Modification Assessment Report MOD 7531

Modification (2) of DA 6968 – alignment of fibre
optical cable and infrastructure

Modification to the approved subdivision and
telecommunications facility at the Cat Shed,
Thredbo Alpine Resort, Kosciuszko National
Park

Secretary's Environmental Assessment Report
Section 96(1A) of the
Environmental Planning and Assessment Act 1979

Figure 2: Revised alignment of cable from the approved tower to Telstra pit on opposite side of Thredbo River (Source: Applicant's MOD documentation)

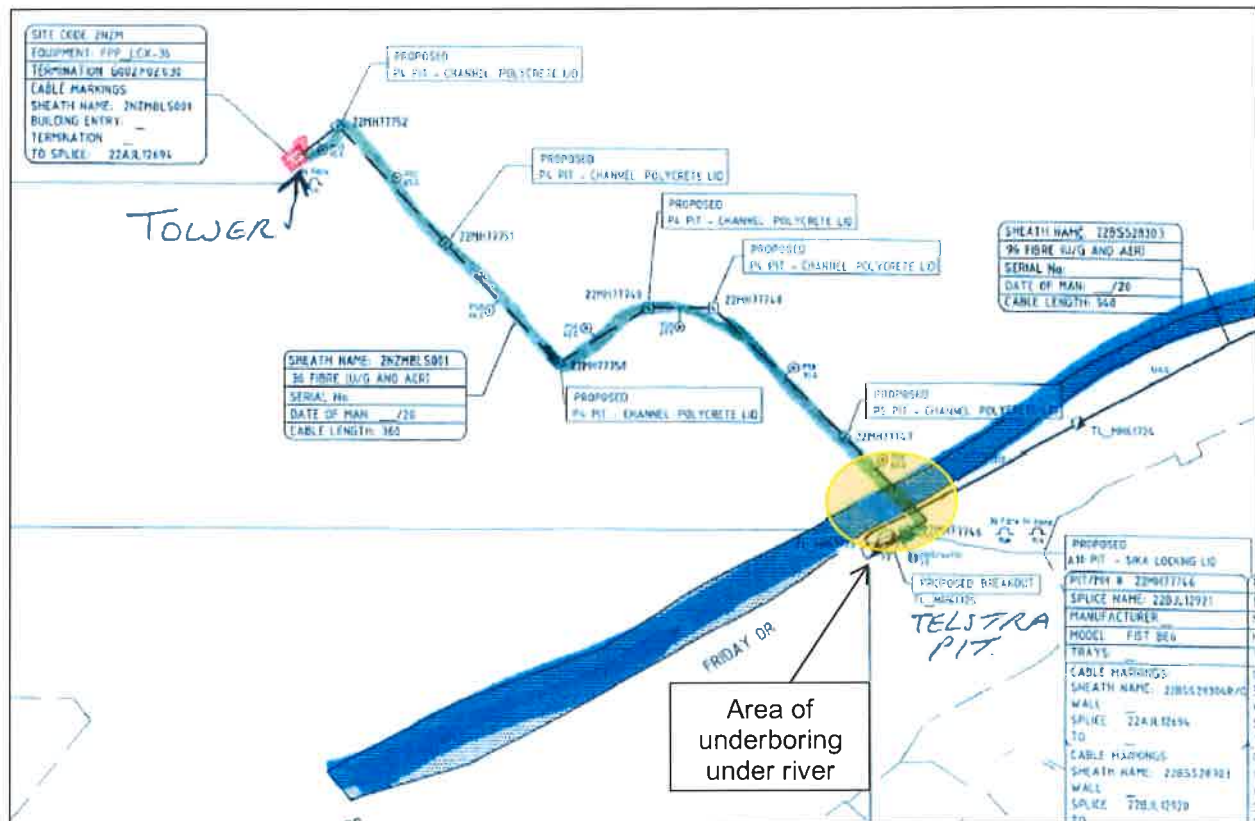
The modification seeks to realign the fibre optical cable route (via underboring) from the approved tower location down the Snowgum chair lift clearing and along disturbed ski slopes before going under the Thredbo River.

- the proposal minimises potential environmental impacts through utilising underboring instead of digging trenches along the revised alignment; and

- disturbance above ground level is minimised by the construction of only installing seven new pits to service the fibre optical cable.

The Department is satisfied that the proposal is appropriate and the Applicant has adequately considered its impact upon the natural environment by providing the revised alignment through previously disturbed ski slopes. Where the works disturb the existing ground level (introduction of the pits), the Department notes that the exhumed material will be backfilled around the pit and then the ground levelled.

Figure 3: Illustration of underbore technique beneath Thredbo River (Source: Applicant's MOD documentation)

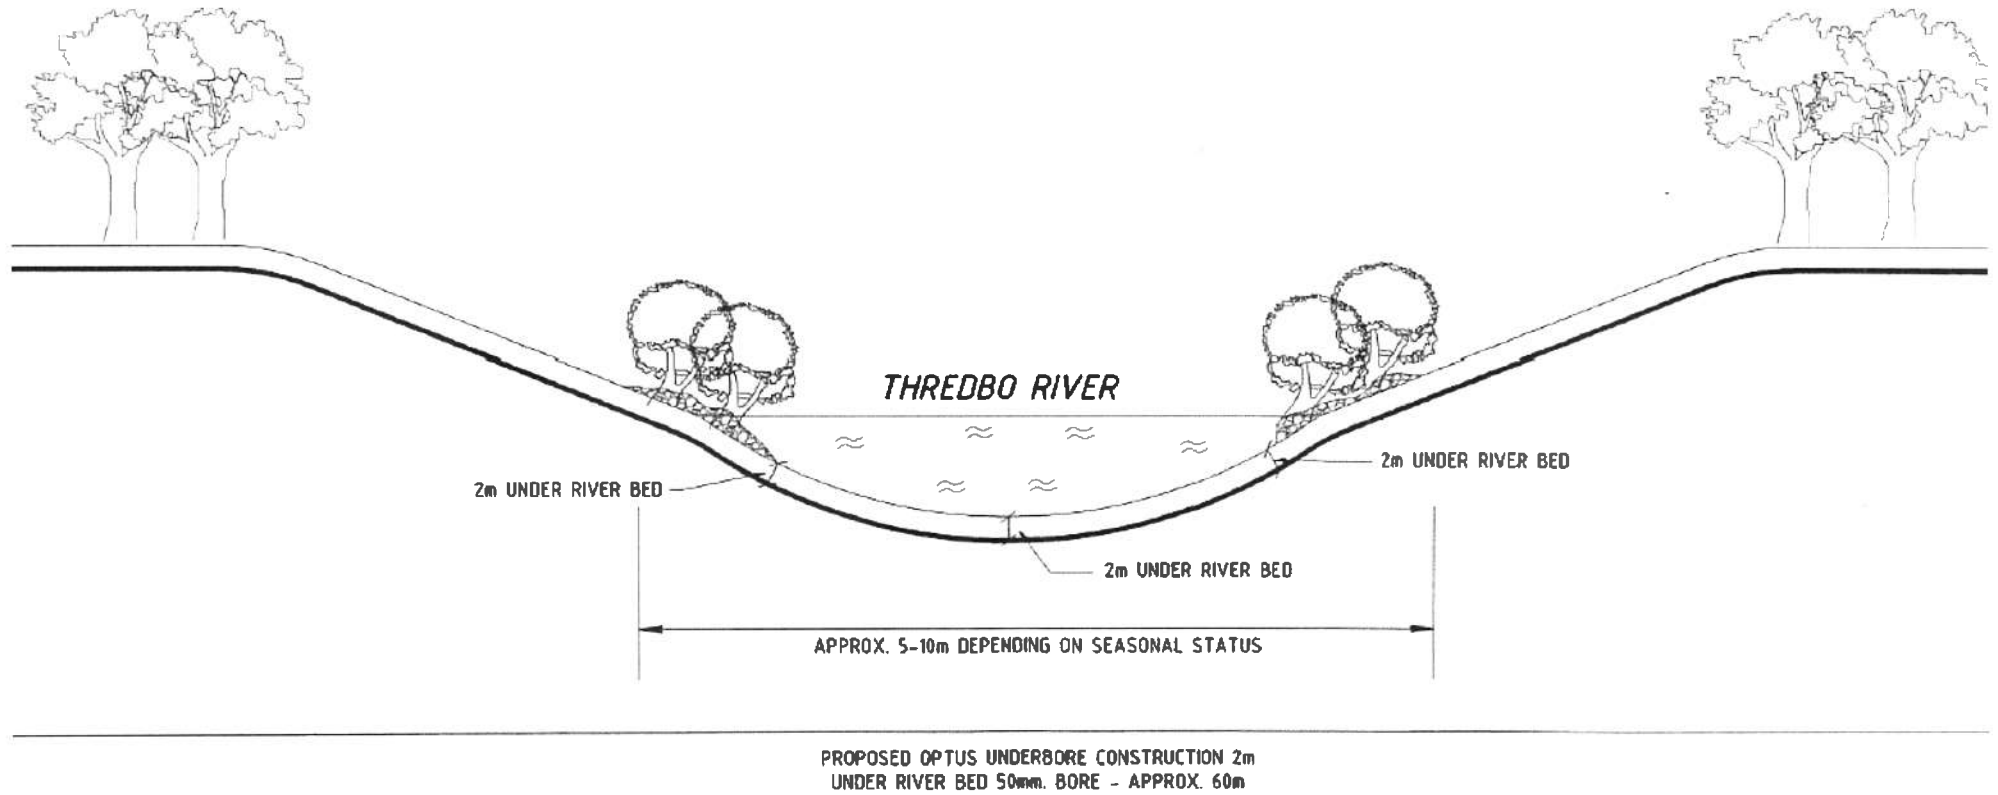
Works are to be carried out on disturbed ski slope and no trees / shrubs are proposed to be removed as a result of the proposed works. The underboring is proposed to be undertaken 1.6 metres below the surface, except for under the Thredbo River where it is proposed to be a minimum of 2 metres below the river bed (**Figure 3**).

Comments received from the OEH, questioned whether a contingency plan should be provided to address events such as when sub-surface rocks are encountered during the works. The Applicant has provided further information in relation to the type of drill to be used and also options should sub-surface rocks be encountered and the drill is unable to drill through the rock. The information provided is considered to be acceptable and enables the Department to progress the application.

The proposal still remains substantial the same as originally approved and there will be minimal environmental impact as a result of the realignment. The NSW Office of Water has requested that the Applicant obtain a CAA for the underboring of the Thredbo River prior to commencement of works. No new Section 79C(1) matters are raised as a result of the amended alignment than originally considered.
